### **DIRECT PUSH GROUNDWATER CONTINUATION SAMPLING AND ANALYSIS PLAN**

**FINAL  
Revision 2**

**RE: Revision 2 – Draft 2009 Direct Push Groundwater Continuation Sampling and Analysis Plan** *BSK*

Re: *Direct Push Groundwater Continuation Sampling and Analysis Plan, Revision 0*,  
April 2009

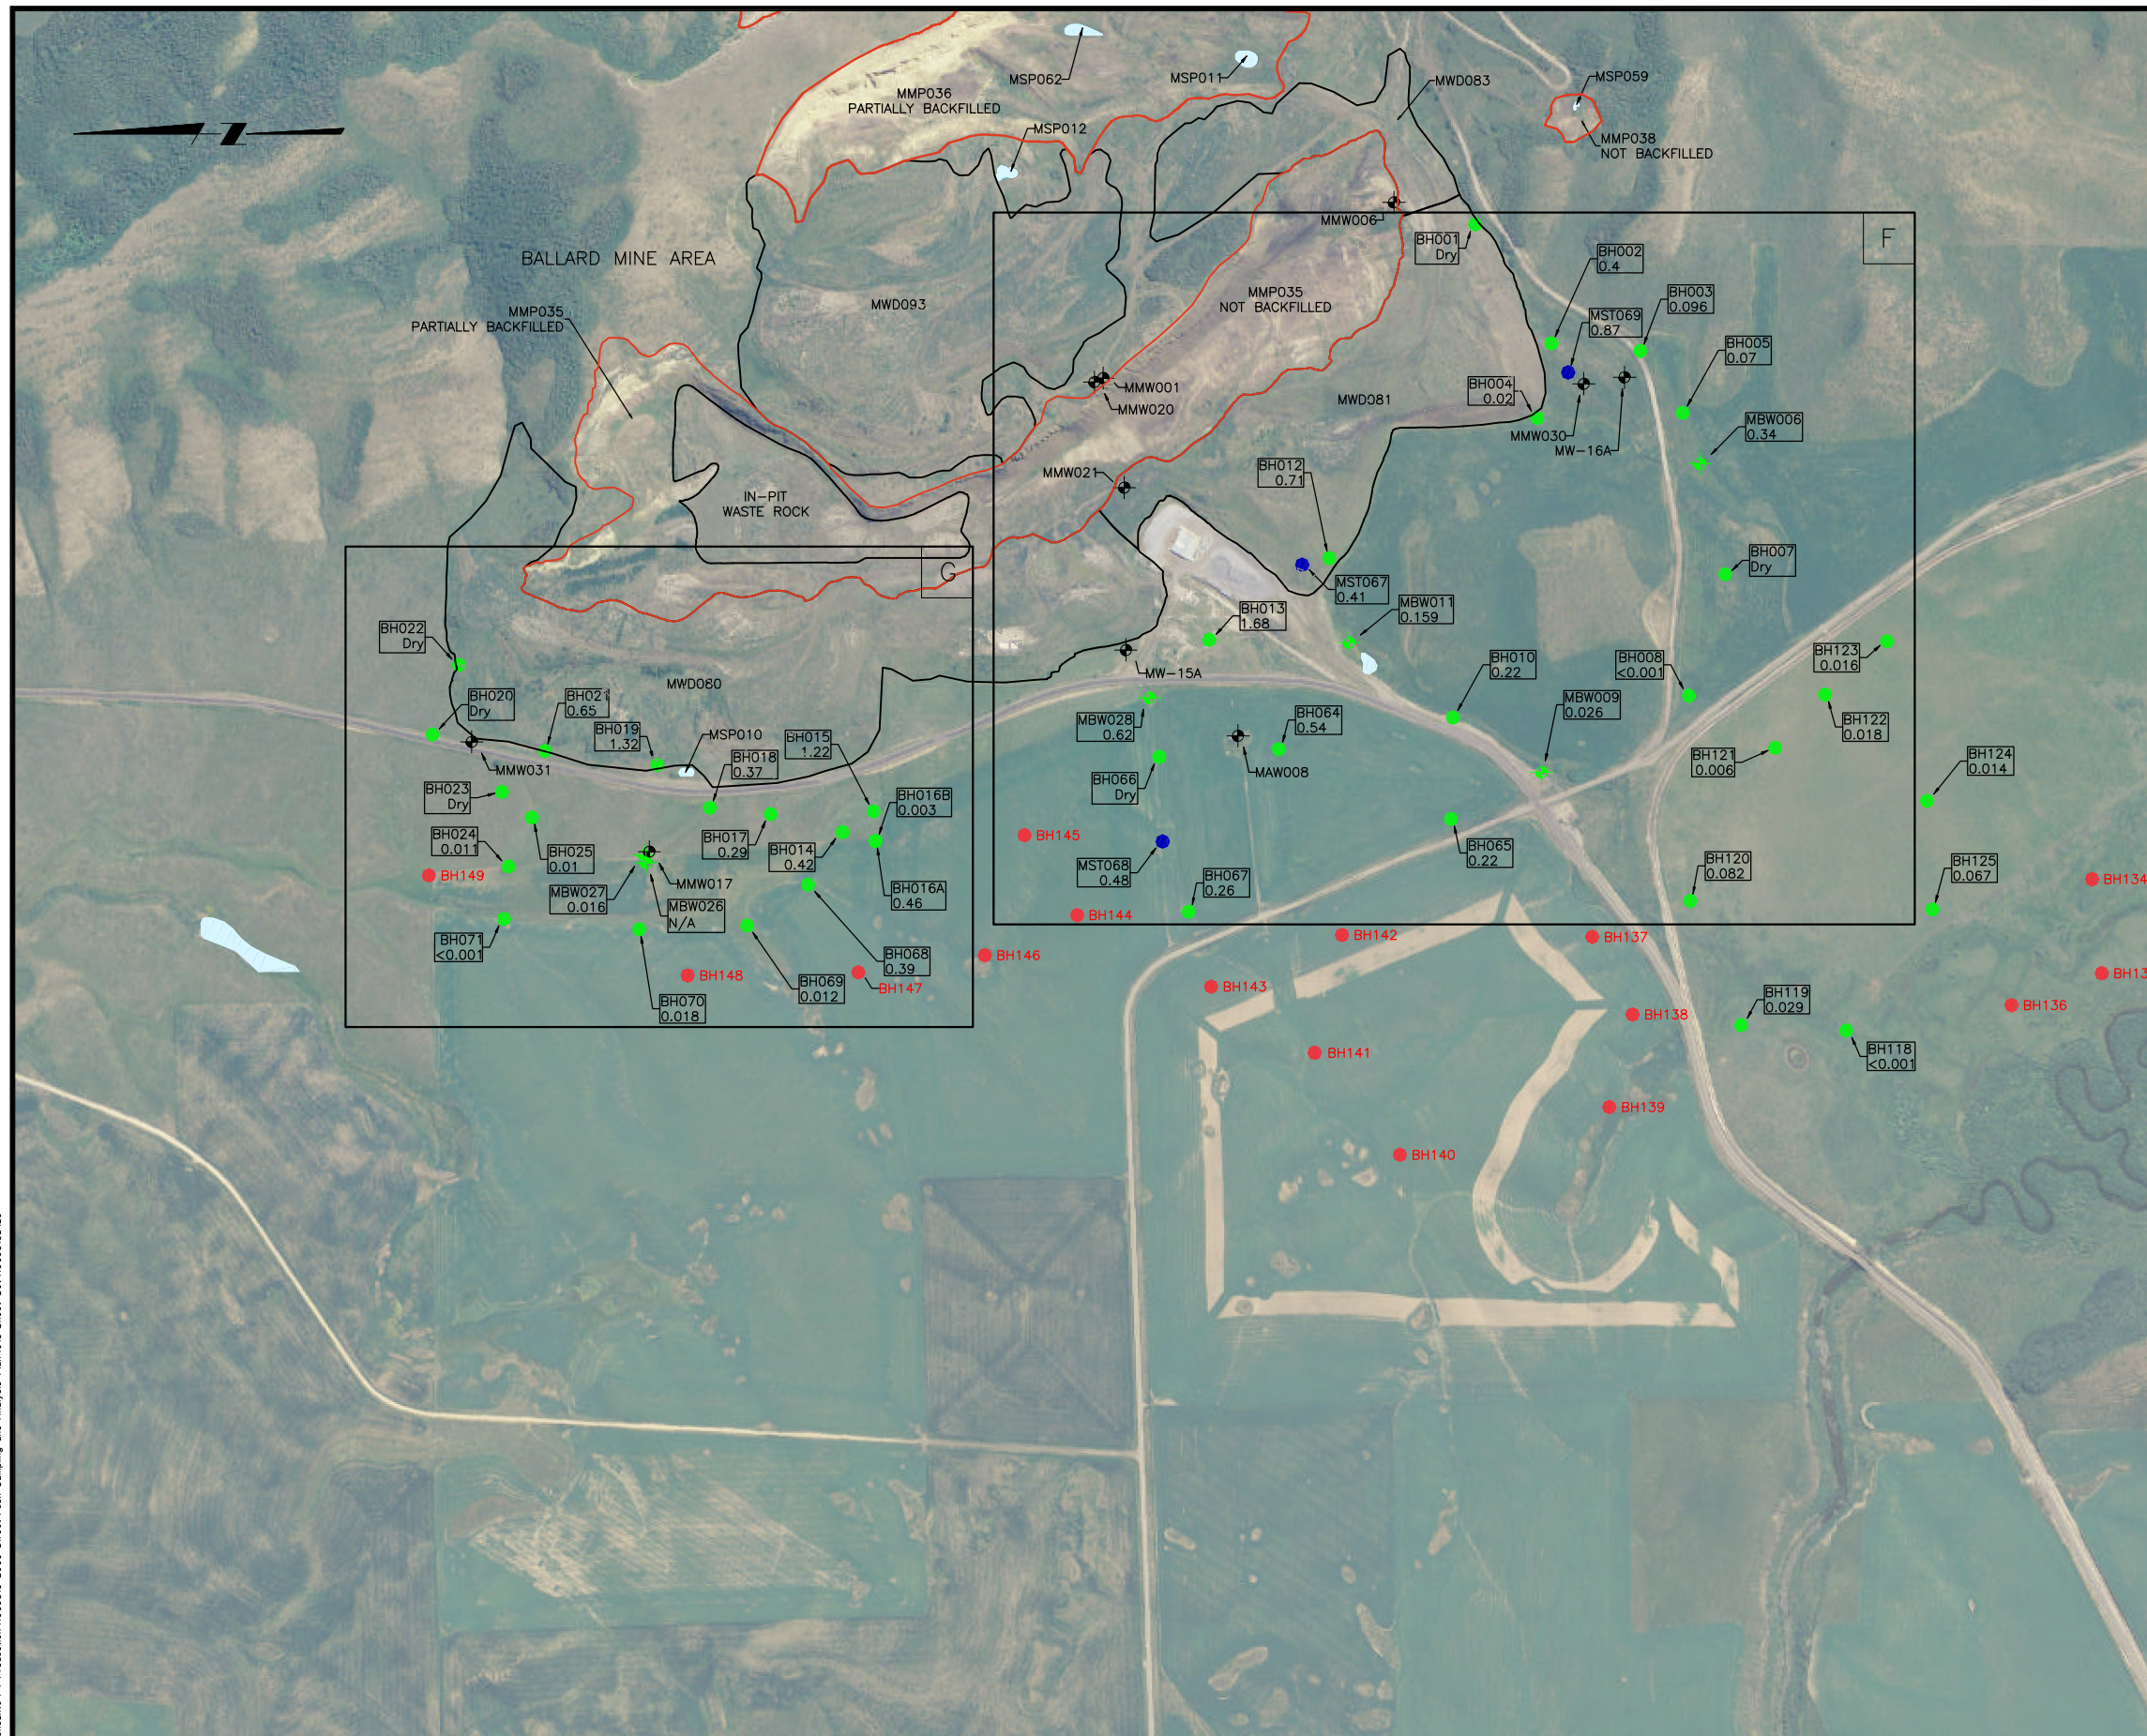
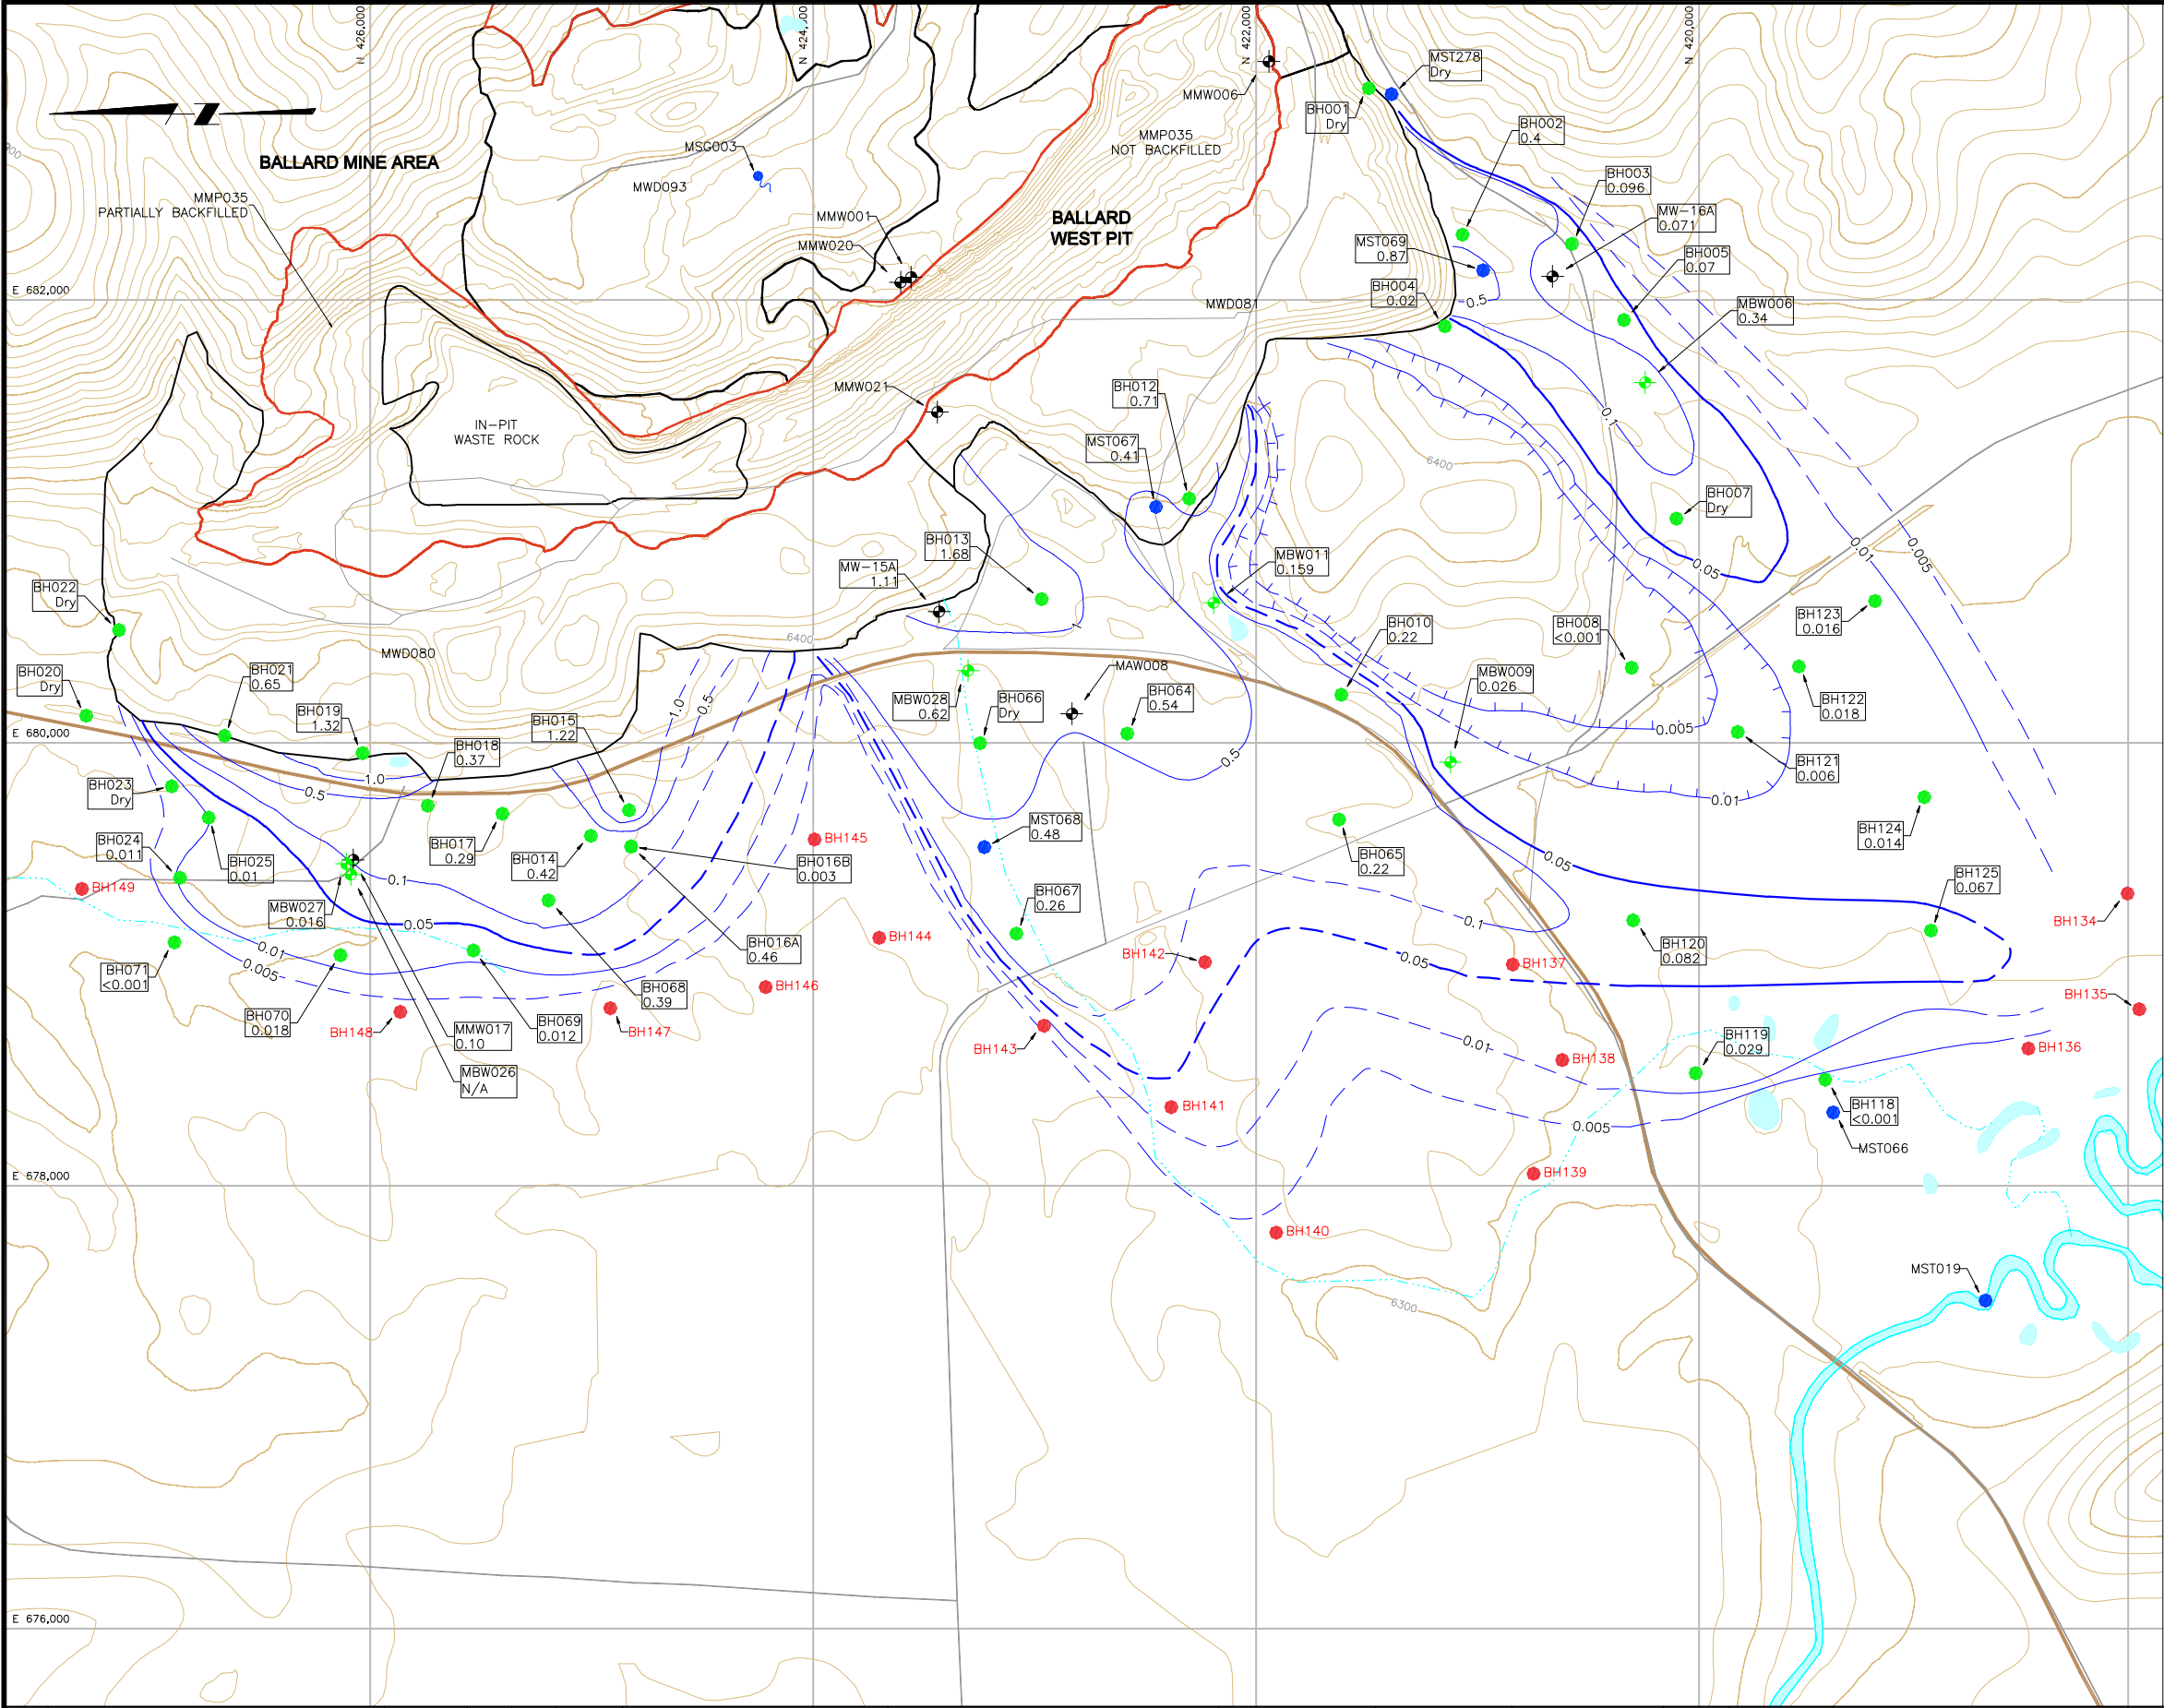
- As discussed during the April 14 April 2009 meeting between P4/Monsanto, MWH, Agencies, and Tribes in Pocatello, add and/or move DP borehole locations to better define the extent of the selenium plume west of Ballard Mine MWD080 in the area between and west of BH016 and BH067.

0-B. Ballard – East Side. A borehole will be added to the southwest of the proposed location for borehole BH133.

- As discussed during the April 14 April 2009 meeting between P4/Monsanto, MWH, Agencies, and Tribes in Pocatello, add and/or move DP borehole locations to better define the extent of the selenium plume west of Ballard Mine MWD080 in the area between and west of BH016 and BH067.

Response: *An additional borehole has been added at the location as requested as shown on the revised Drawings 4 and 5.*

Response: *An additional borehole has been added to infill the area indicated as show on the revised Drawings 4 and 5.*
